ENGINEER'S CERTIFICATION (HYDROLOGY) FOR PERMANENT CERTIFICATE OF OCCUPANCY
I, Steven K. Morrow, NMPE 13679, of the firm Brasher and Lorenz, Inc., hereby certify that this project has been graded and will drain in substantial compliance with and in accordance with the design intent of the approved plan dated 1-17-12. The record information edited onto the original design document has been obtained by me or under my direct supervision as supplemental data to the original topographic survey prepared by Lenore Armijo NMPS# 15511 of the firm Brasher and Lorenz, Inc. and is true and correct to the best of my knowledge and belief. This certification is submitted in support of a request for Permanent Certificate of Occupancy.

GRADING AND DRAINAGE PLAN
SCALE: 1" = 10'

8324 WASHINGTON STREET N.W.
DETAILED GRADING AND DRAINAGE PLAN

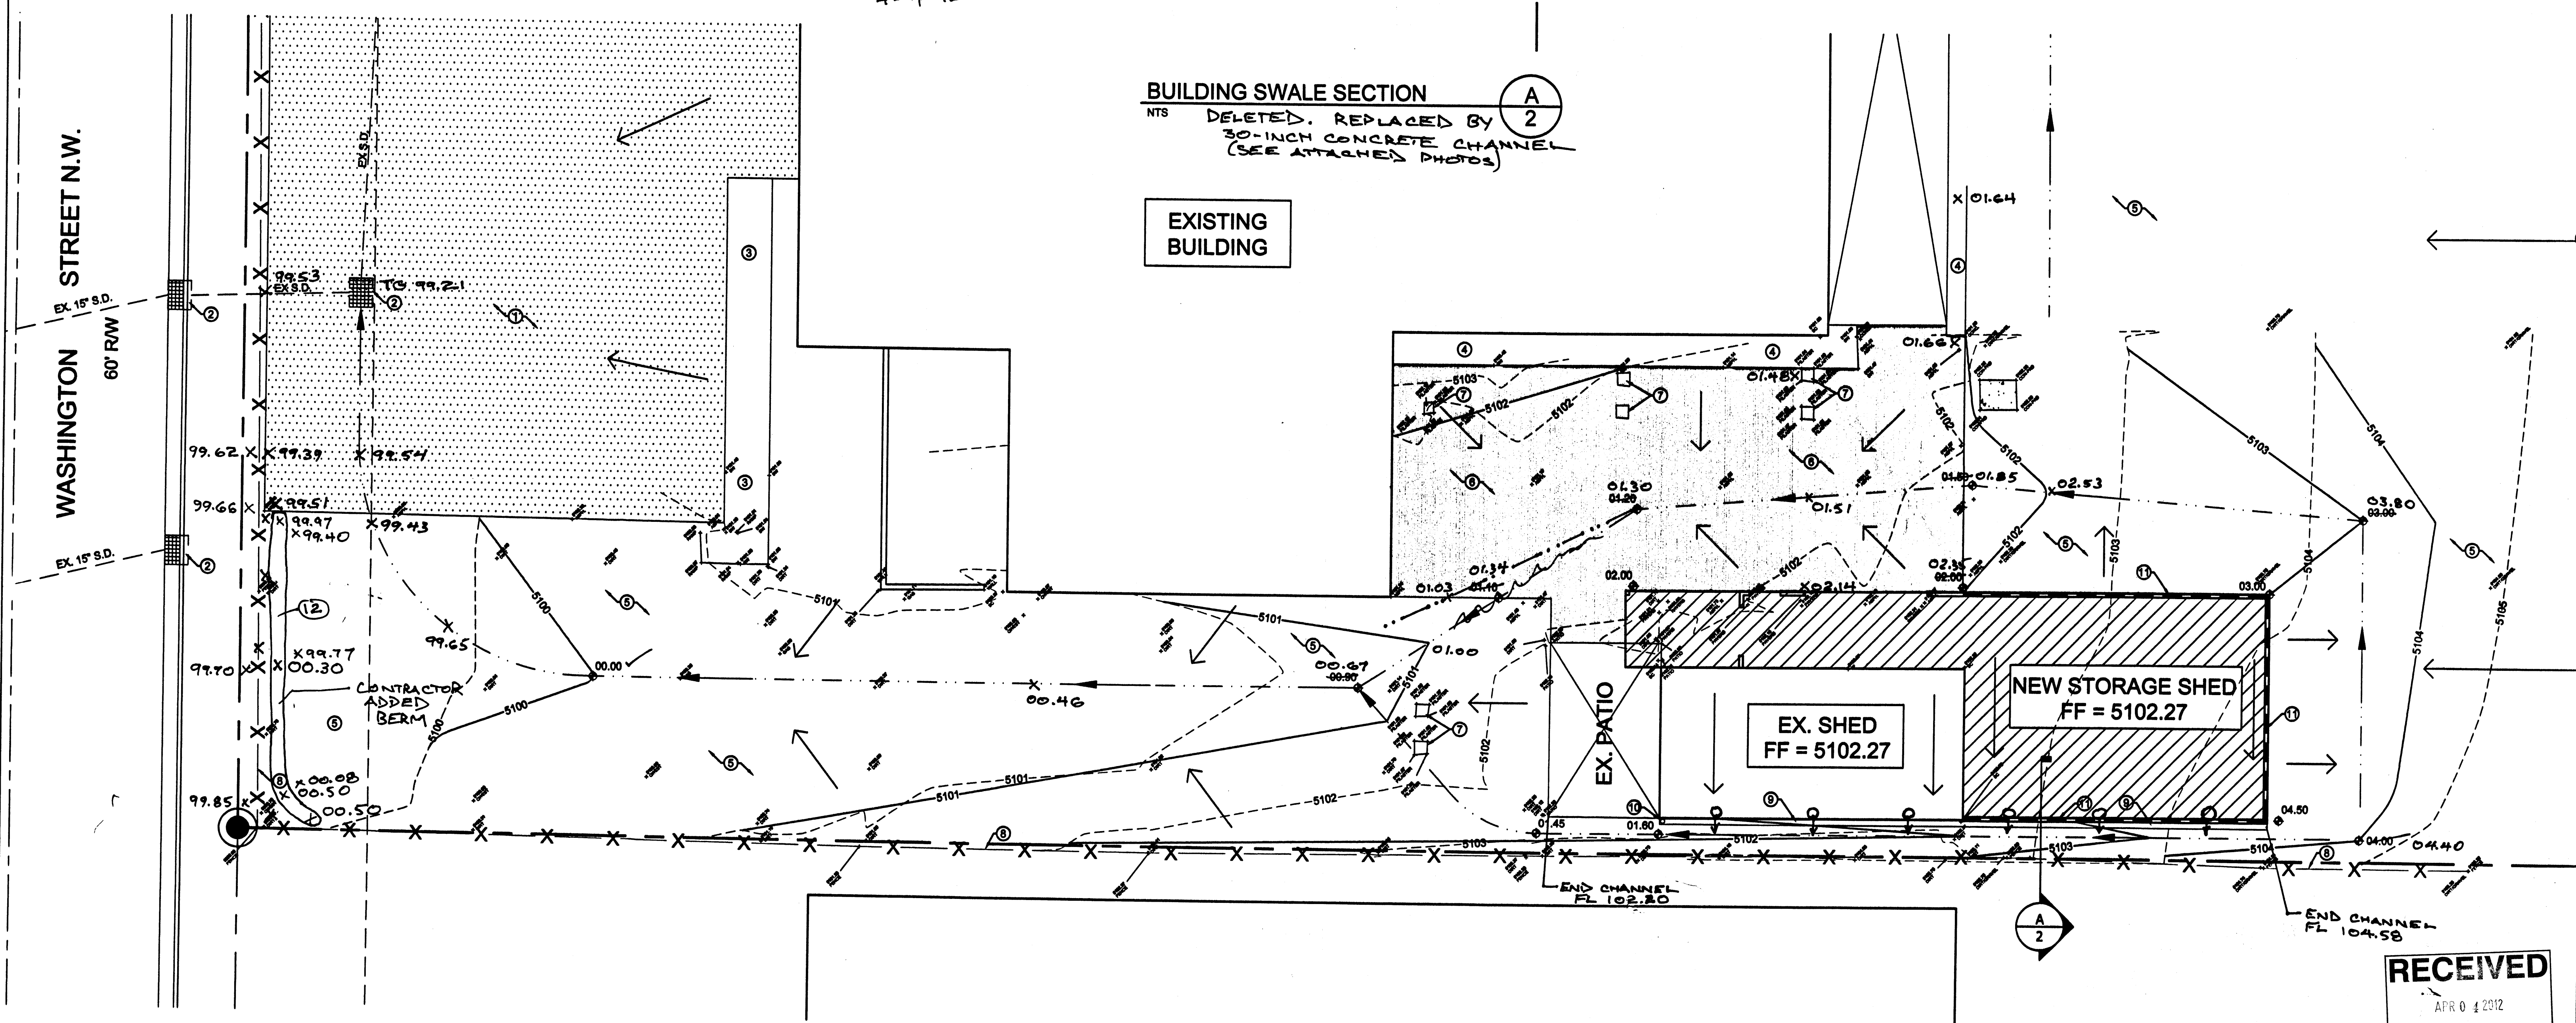
1. The swale on the south side of the building was not constructed. Instead, a 30-inch concrete channel was constructed adjacent to the building (see attached photos).
2. As-built elevations indicated that runoff may drain directly to the street instead of to the private on-site drop inlet (as called for in the plan). **CONTRACTOR CONSTRUCTED EARTHEN BERM TO CORRECT THIS. SEE NOTE #12.**
3. Gravel areas are now a graded dirt surface.

NTS DELETED. REPLACED BY 30-INCH CONCRETE CHANNEL (SEE ATTACHED PHOTOS)

1. EXISTING ASPHALT PAVING.
2. EXISTING DROP INLET.
3. EXISTING CONCRETE SIDEWALK.
4. EXISTING CONCRETE SLAB.
5. ~~EXISTING GRAVEL YARD~~ GRADED DIRT SURFACE
6. REMOVE AND DISPOSE EXISTING ASPHALT. RE-PAVE TO LIMITS SHOWN.
7. REMOVE AND DISPOSE EXISTING CONCRETE FOUNDATIONS.
8. EXISTING CHAIN LINK FENCE TO BE REMAIN.
9. ~~INSTALL GUTTER ALONG ENTIRE SOUTH SIDE OF BUILDING~~ DELETED
10. ~~DOWNSPOUT~~ DELETED
11. STEMWALL.
12. EARTHEN BEAM

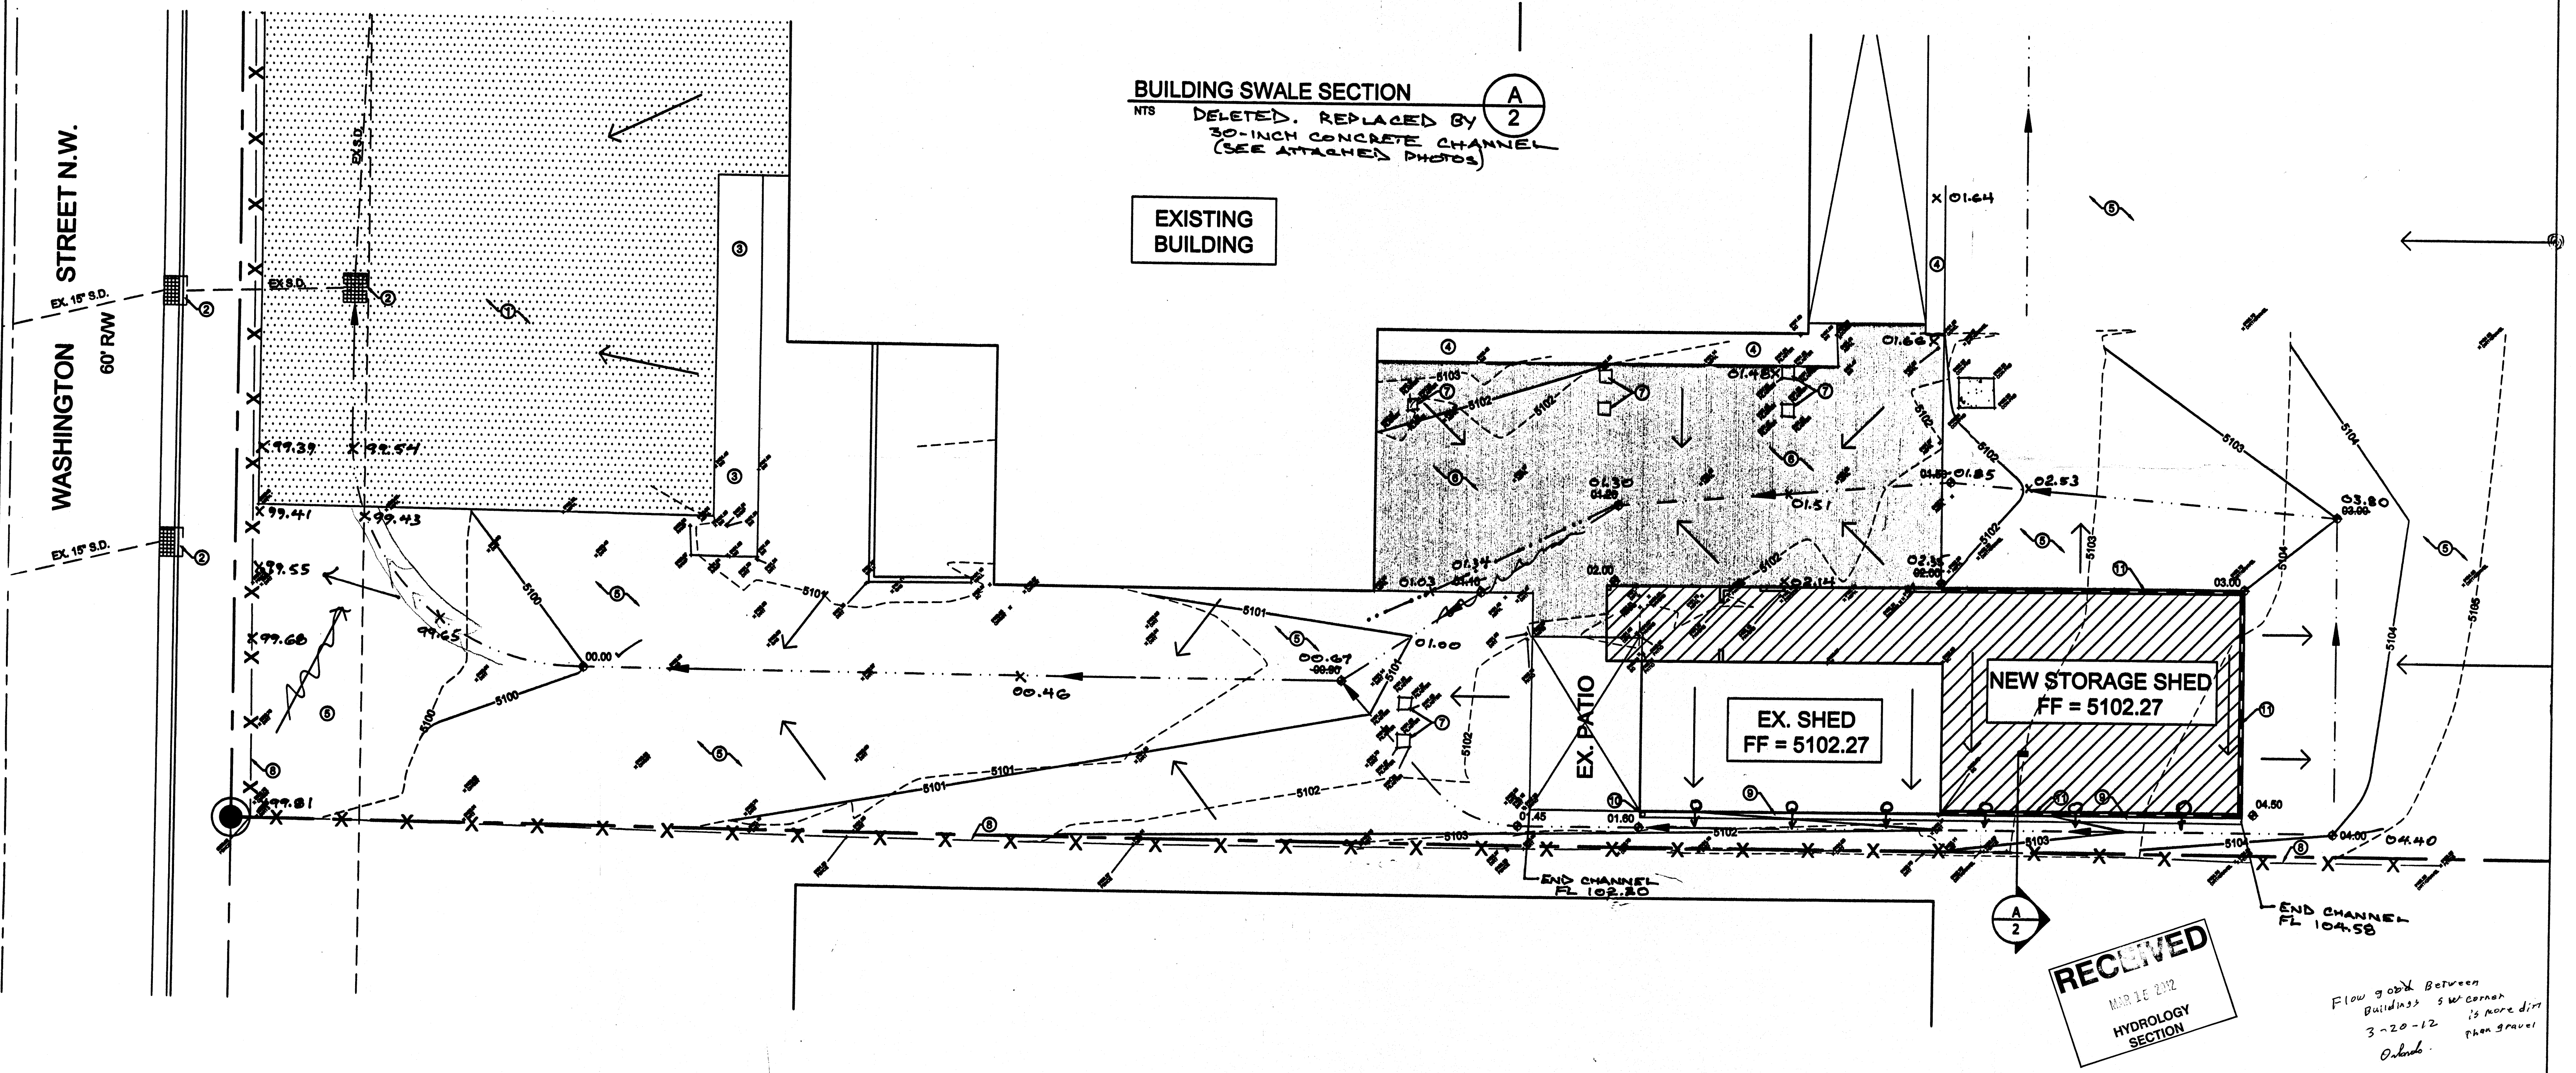
1. The swale on the south side of the building was not constructed. Instead, a 30-inch concrete channel was constructed adjacent to the building (see attached photos).
2. As-built elevations indicated that runoff may drain directly to the street instead of to the private on-site drop inlet (as called for in the plan).
3. Gravel areas are now a graded dirt surface.

BUILDING SWALE SECTION
NTS DELETED. REPLACED BY 30-INCH CONCRETE CHANNEL (SEE ATTACHED PHOTOS)

- KEYED NOTES**
1. EXISTING ASPHALT PAVING.
 2. EXISTING DROP INLET.
 3. EXISTING CONCRETE SIDEWALK.
 4. EXISTING CONCRETE SLAB.
 5. EXISTING GRAVEL-YARD **GRADED DIRT SURFACE**
 6. REMOVE AND DISPOSE EXISTING ASPHALT. RE-PAVE TO LIMITS SHOWN.
 7. REMOVE AND DISPOSE EXISTING CONCRETE FOUNDATIONS.
 8. EXISTING CHAIN LINK FENCE TO BE REMAIN.
 9. **INSTALL GUTTER ALONG ENTIRE SOUTH SIDE OF BUILDING DELETED**
 10. **DOWNSPOUT DELETED**
 11. STEM WALL.
